[Docket No. FAA-2022-1647; Project Identifier AD-2022-01379-T; Amendment 39-22438; AD 2023-10-02]

#### Airworthiness Directives; Transport and Commuter Category Airplanes

**ACTION:** Final rule.

**Figure 1 to paragraph (g)(1)(i) – Fundamental Effective Isotropic PSD at Outside Interface of Airplane Antenna**

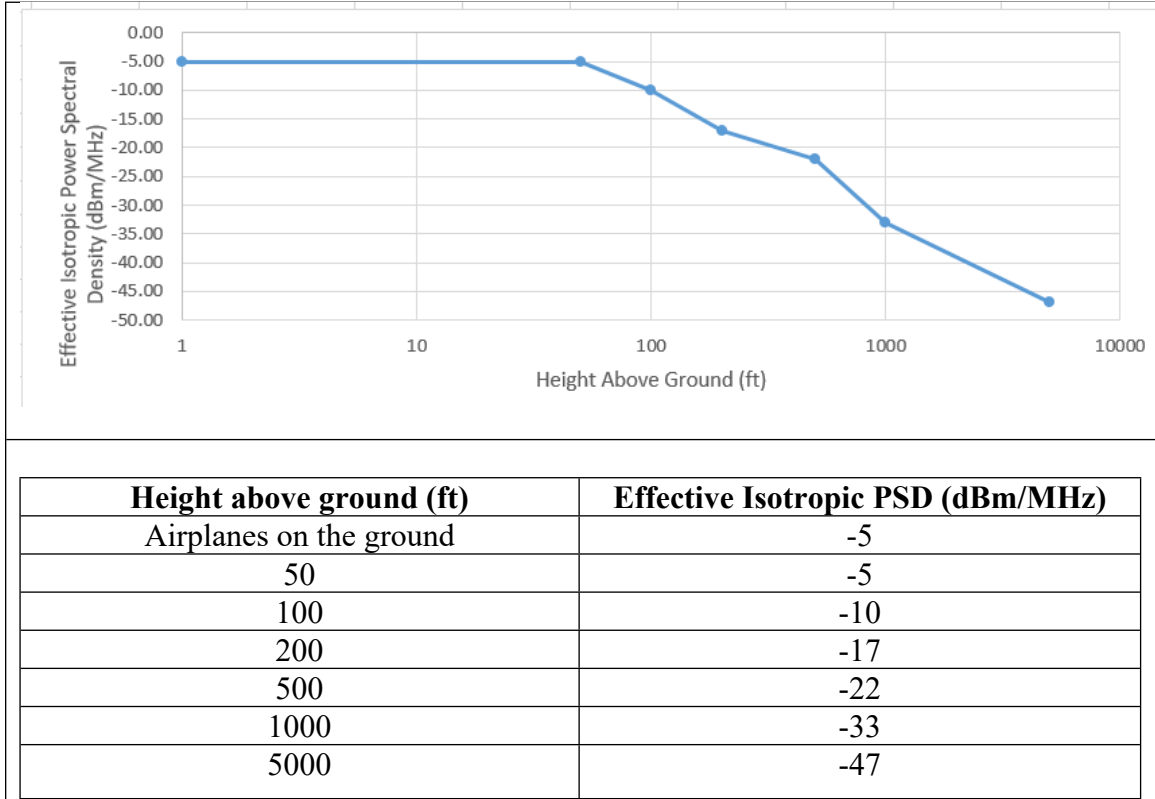
*Comment summary:* Textron Aviation requested the FAA clarify at what reference point the PSD requirements apply. The commenter stated it assumed that they apply at the radio altimeter receive antenna input, such that antenna characteristics, coax loss, and filter characteristics would be included in the determination.

*Comment summary:* Thales requested that the radio altimeter performance criteria specified in figure 1 to paragraph (g)(2) of the proposed AD be revised to explicitly cover any 5G emitter station up to 65 dB/MHz in the applicable 3.7–3.98 GHz band.

*FAA response:* The FAA agrees and has changed the title of figure 1 to paragraph (g)(1)(i) of this AD to reflect that the PSD requirements apply at the antenna input to the radio altimeter, and that the figure applies to the outward facing side of the antenna.

*FAA response:* The FAA agrees and has changed paragraphs (g)(1)(i) and (ii) of this AD to include the applicable frequency bands.

**Figure 2 to paragraph (g)(1)(ii): Spurious Effective Isotropic PSD at Outside Interface of Airplane Antenna**

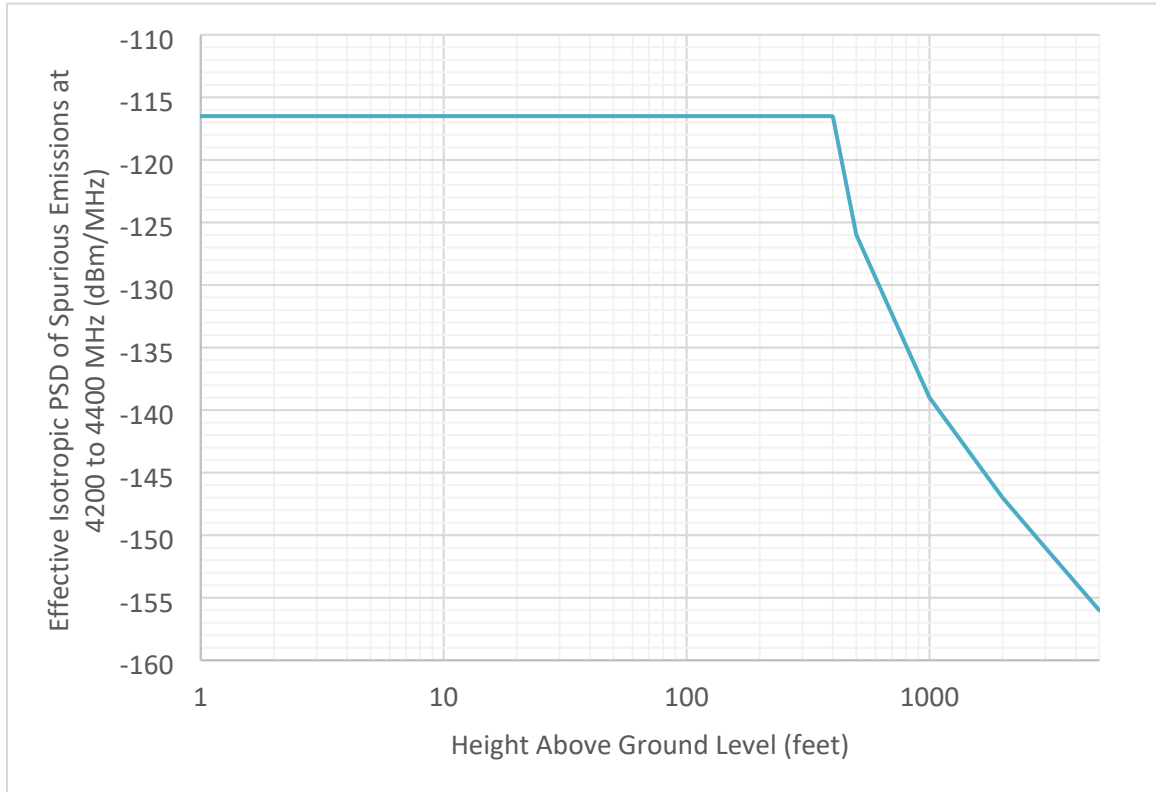
*Comment summary:* AIA requested that the FAA provide more information about the tolerances for determination of whether an airplane is radio altimeter tolerant. Several commenters requested that the FAA add a new figure indicating the spurious tolerance, similar to the figure with the PSD tolerance curve, and a specification of the altitude dependence for spurious tolerance.

*FAA response:* The FAA agrees and has replaced the proposed fixed emission level with a spurious PSD tolerance curve in figure 2 to paragraph (g)(1)(ii) of this AD. Subsequent figures have been redesignated accordingly.
